お詫びと訂正 Correction and apology

組立説明書内に下記の誤りがあります。お詫びと共に下記の通り訂正させていただきますので、ご確認の程、宜しくお願致します。
There is a wrong instruction in the assembly manual. Please see for details below. We apologize and are pleased to correct it. Please kindly refer to the following.

p34.

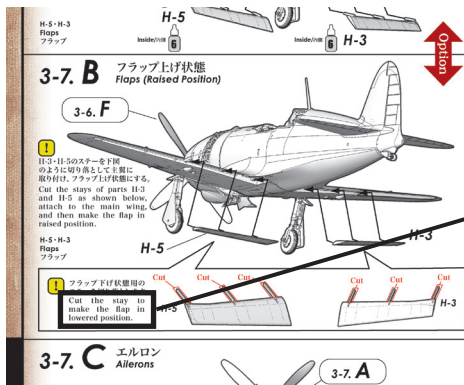
Cut the stay to make the flap in lowered position.
	Cut the stay to make the flap in raised position.
